FIELD REVISION SHEET
THIS SHEET SUPERSEDES SHEET 487

I-81 VIADUCT (COMMUNITY GRID) - CONTRACT 3
CITY OF SYRACUSE
OSWEGO BOULEVARD, SH C56-11
BEAR ST, SH C59-4
COUNTY: ONONDAGA REGION: 03

DRAINAGE AND UTILITY PLANS
N. CLINTON ST
AND GENANT DR

CONTRACT NUMBER D265218

DRAWING NO. DUP-02

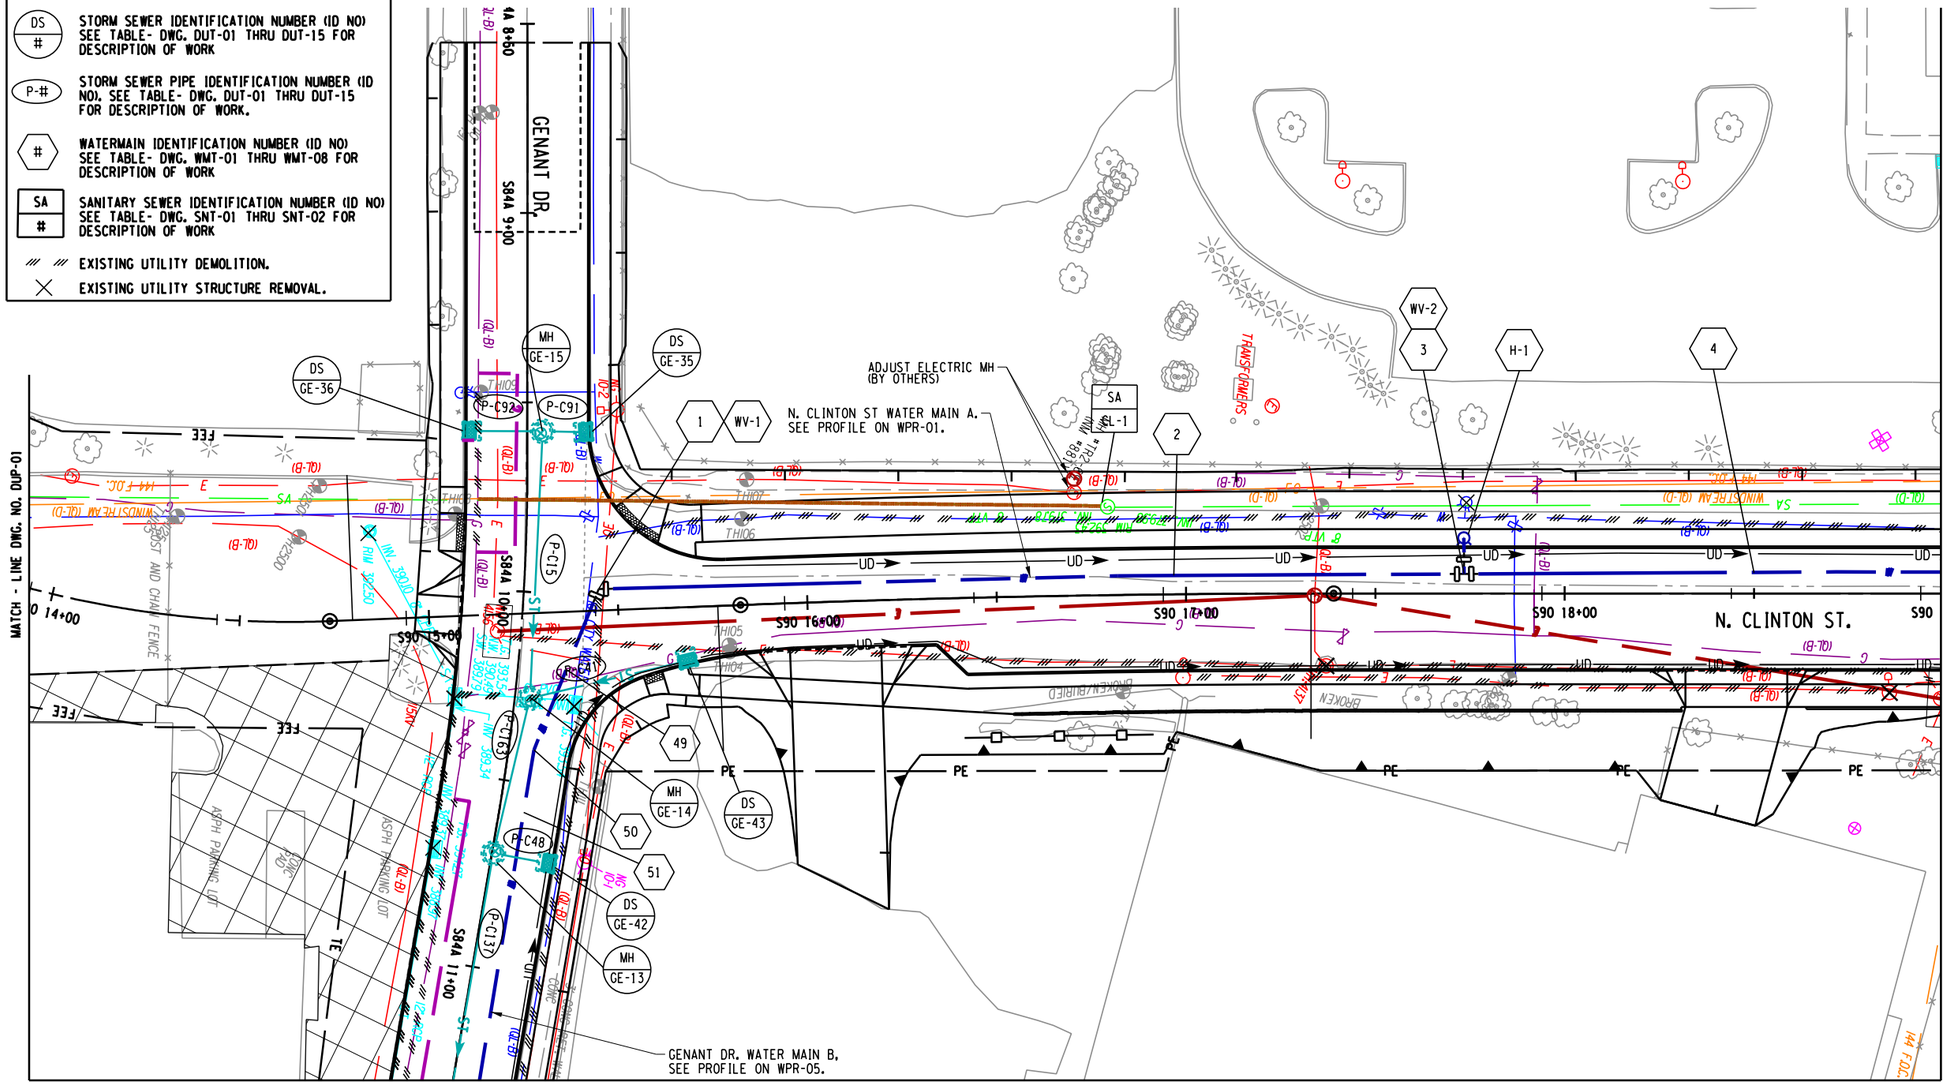
1. REMOVED DS-GE-14 AND P-C82.
2. REMOVED UNDERDRAIN FROM S84A 8+55 TO 12+25 RT AND S84A 8+55 TO 9+58 LT.

DRAWING NO. DUP-04
SHEET NO. 489R4

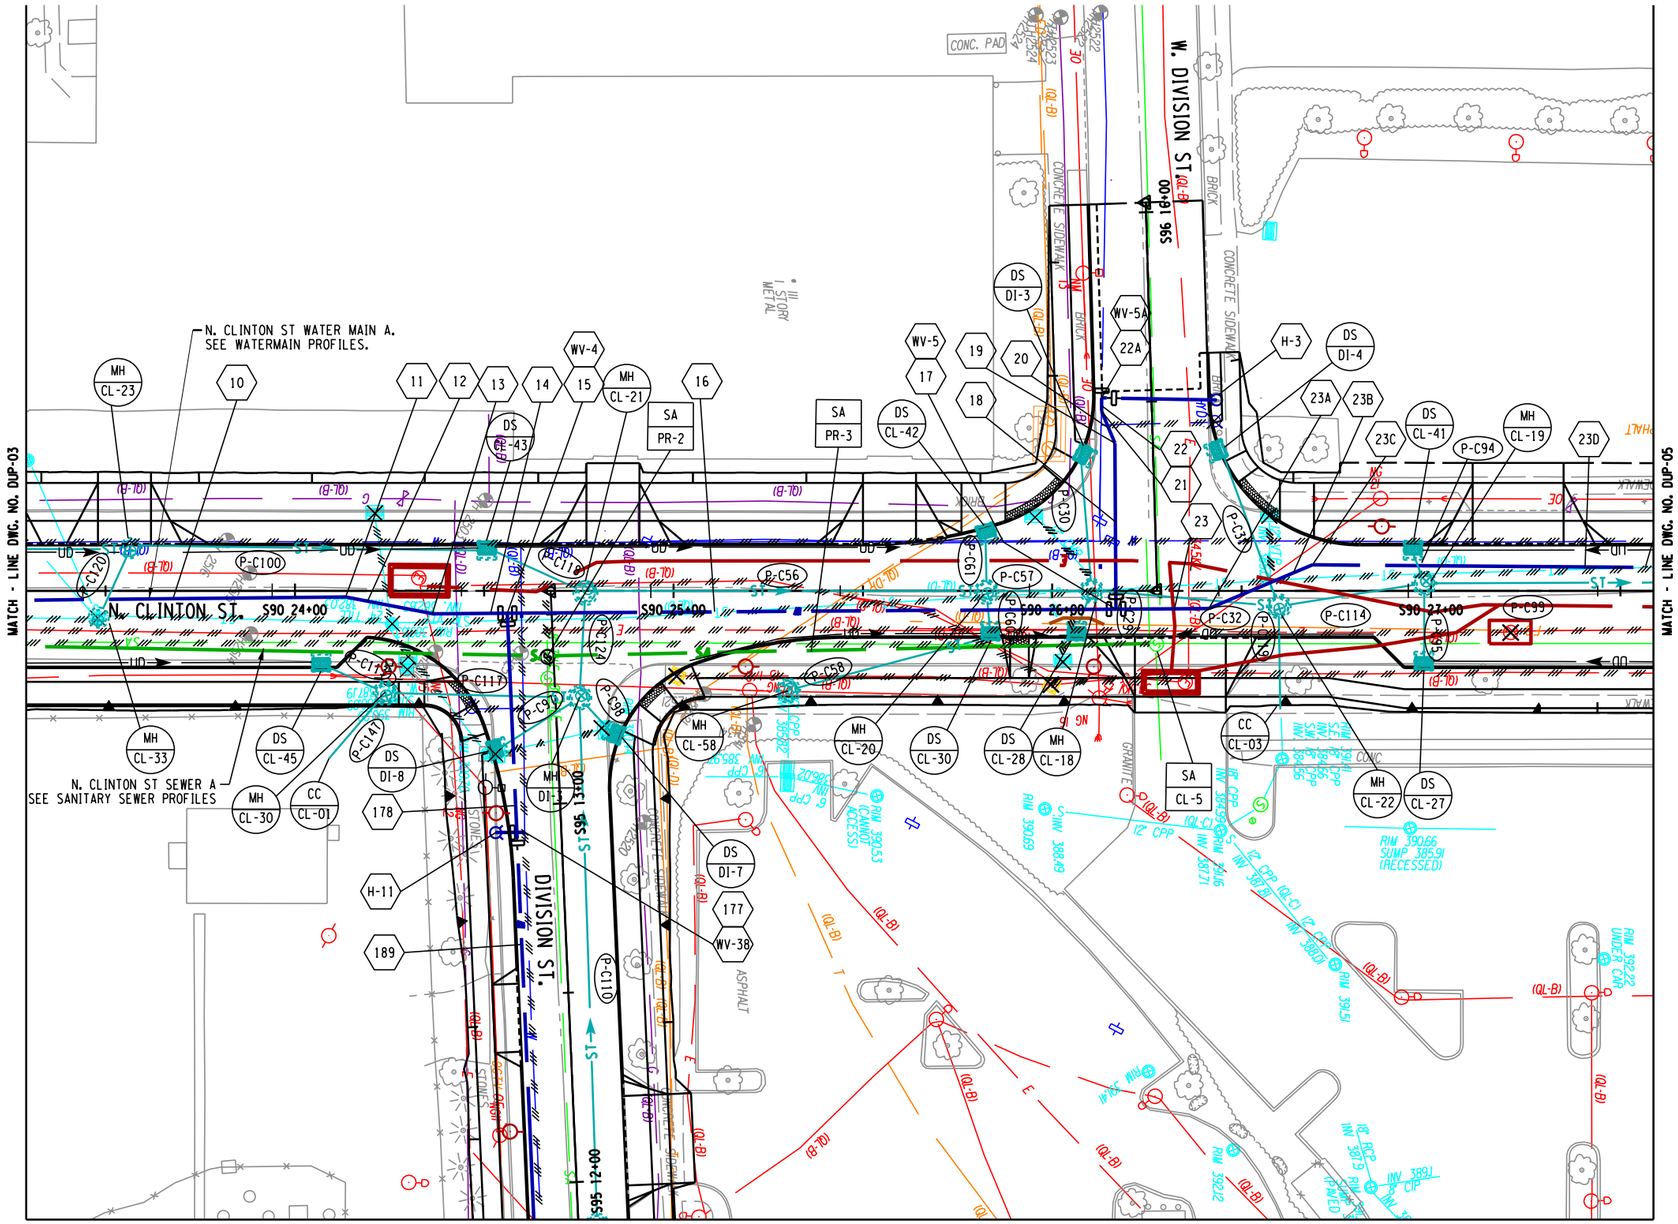
1. RELOCATED WATERLINE FROM BEND 24 TO BEND 30.

DRAWING NO. DUP-09
SHEET NO. 494R2

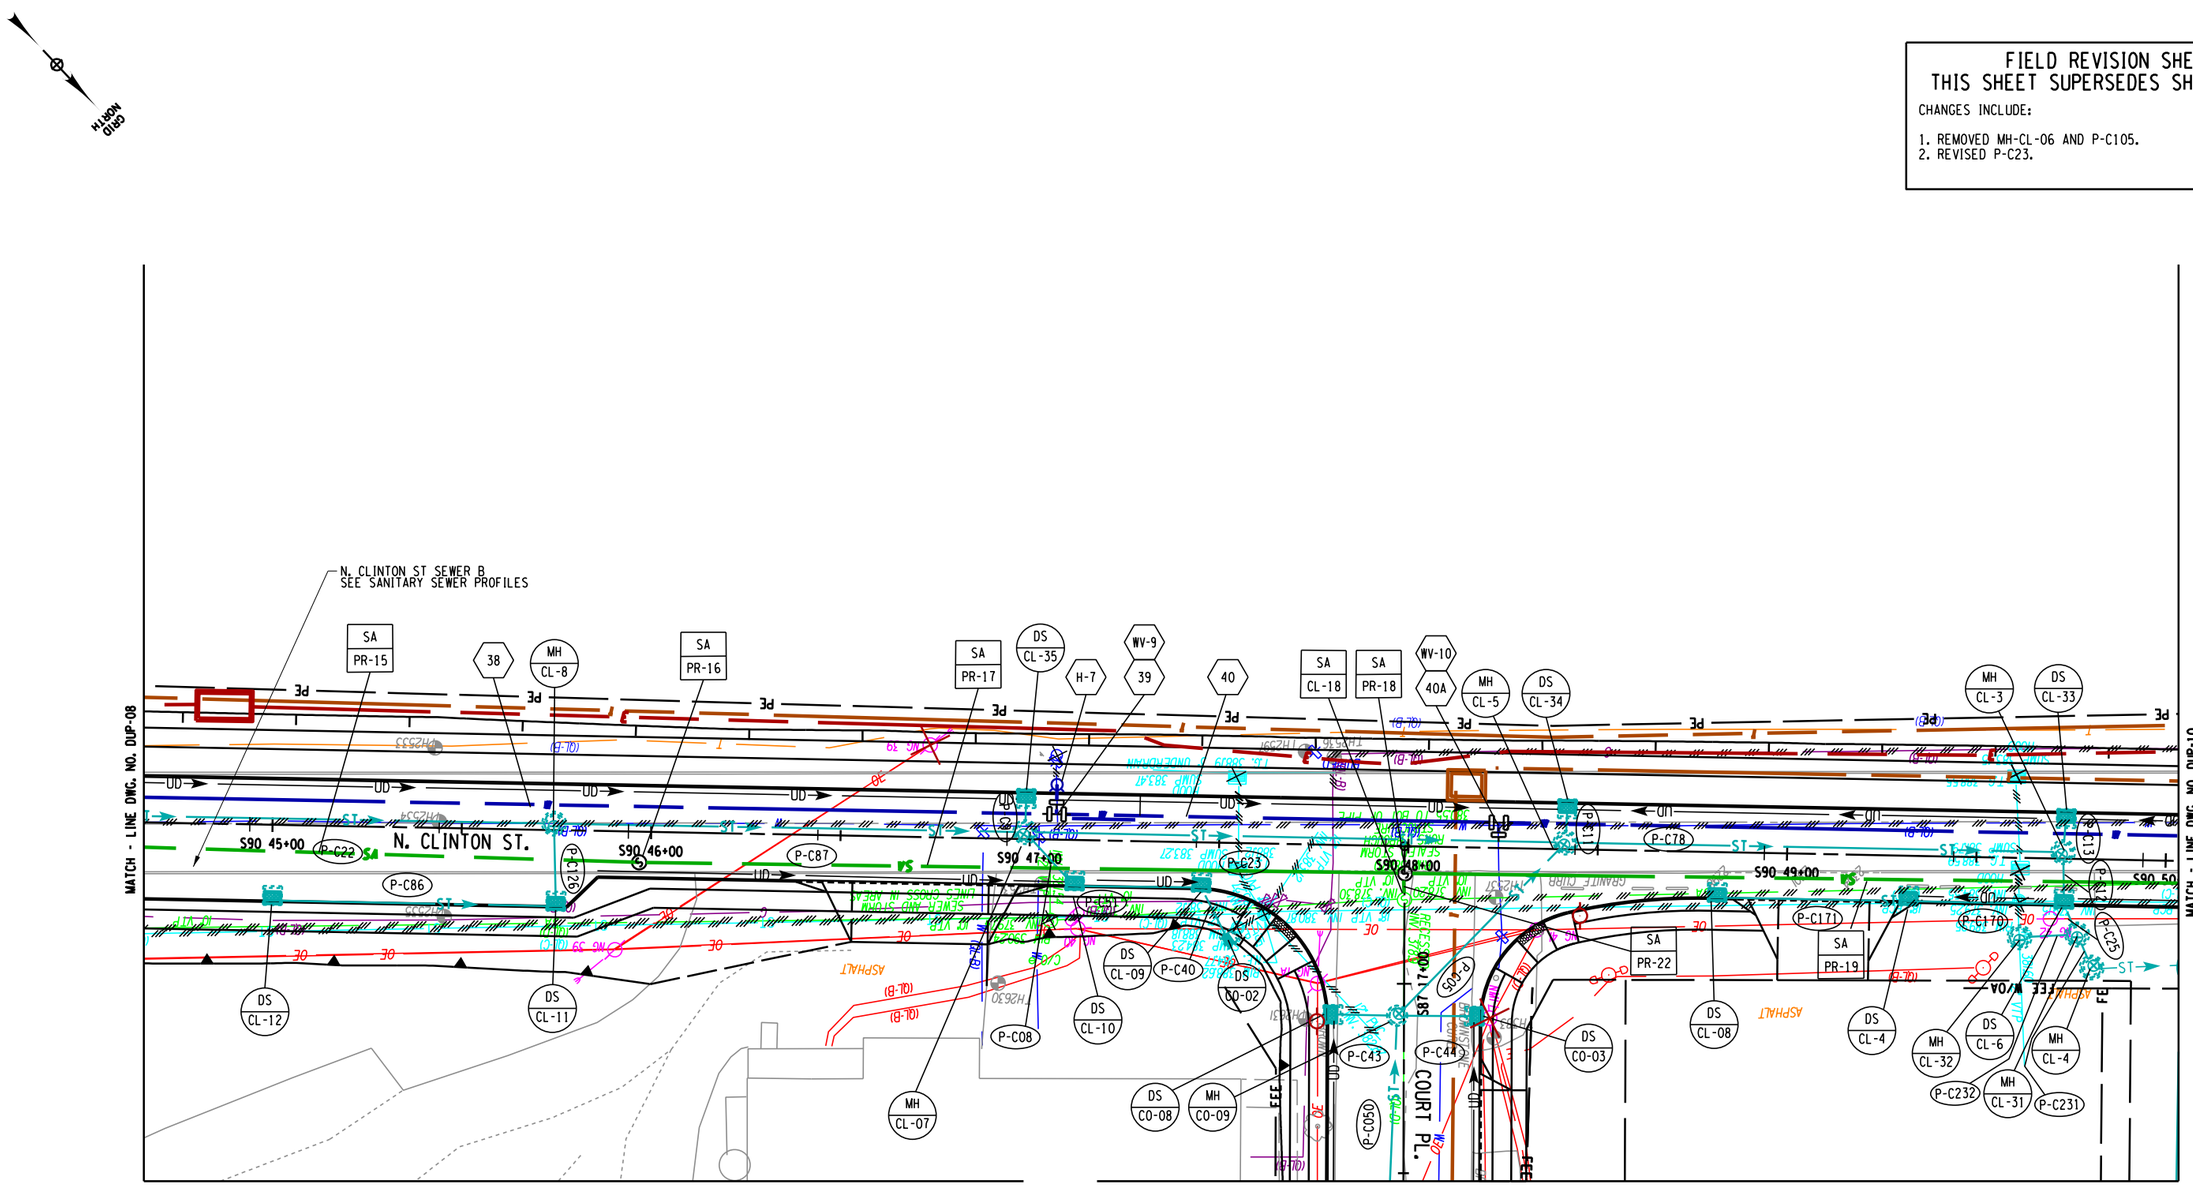
1. ADDED PIPE SA-PR-23.
2. ADDED NEW STRUCTURE SA-CL-20.
3. REMOVED STRUCTURE SA-CL-21.

DRAWING NO. DUP-10
SHEET NO. 495R2

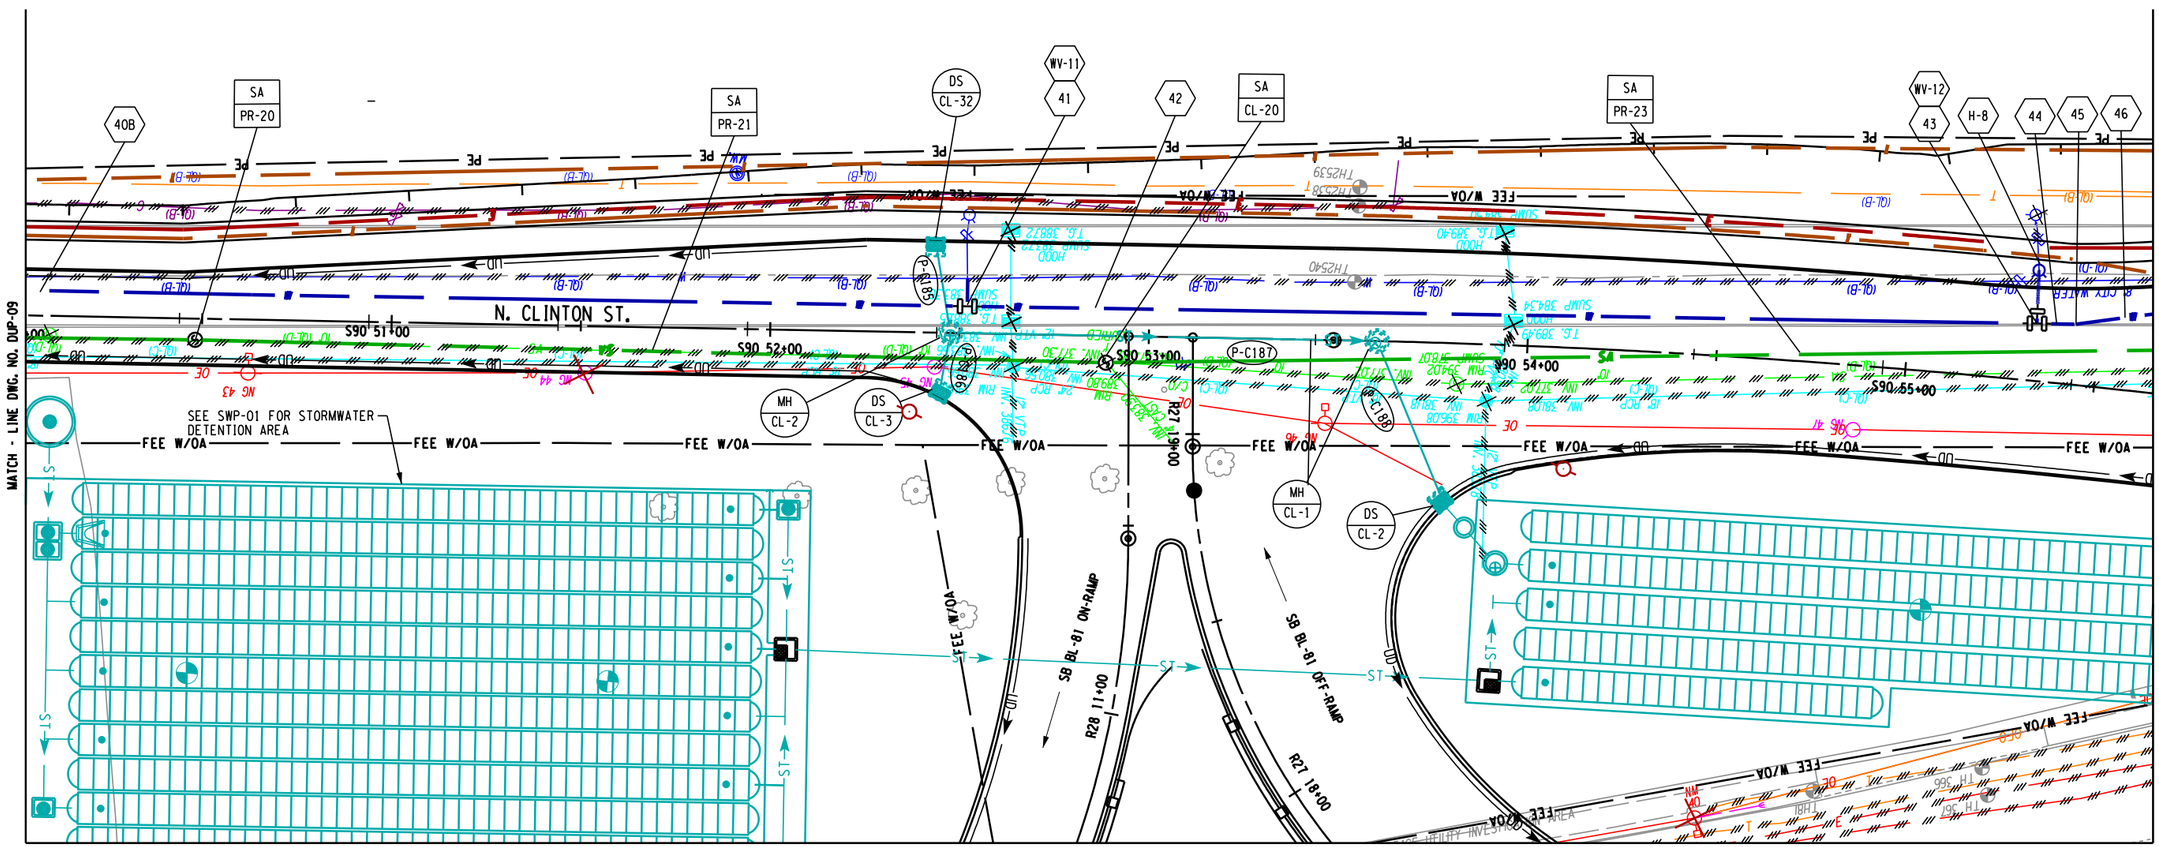
1. REMOVED DS-GE-45, MH-GE-06, P-C139 AND P-C141.
2. REVISED PIPE P-C16 LOCATION AND INLET CONNECTIONS.
3. SHIFTED MANHOLE MH-GE-17.
4. REMOVED UNDERDRAIN FROM S84A 9+57 TO 12+25 RT AND S84A 8+55 TO 9+58 LT.

DRAWING NO. DUP-11
SHEET NO. 496R1

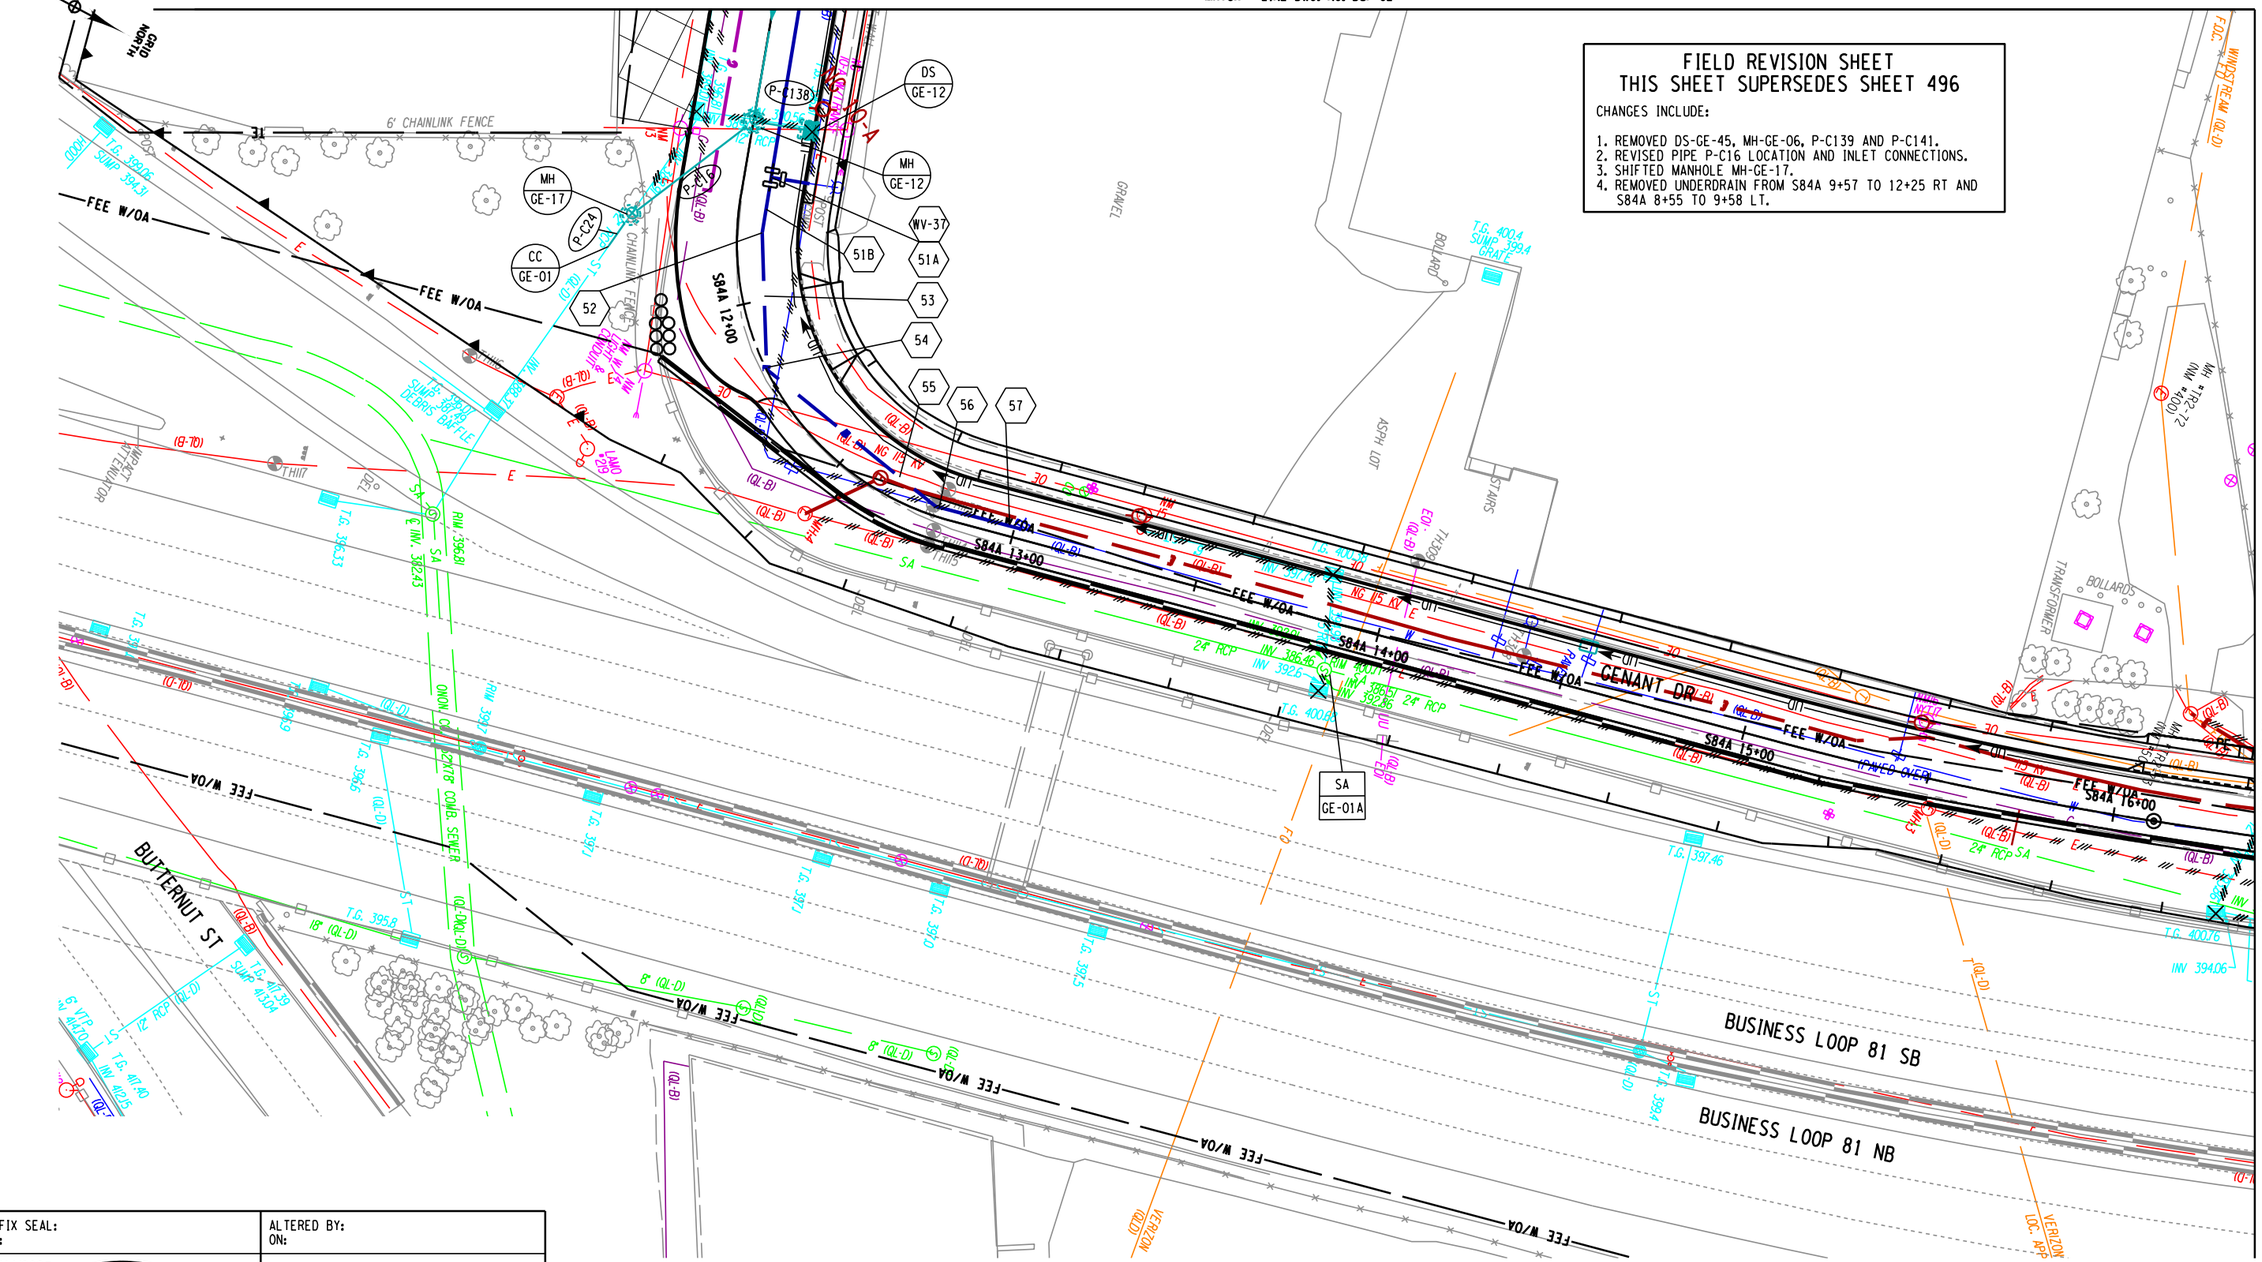
1. REMOVED ADJUSTMENT OF SA-GE-03.
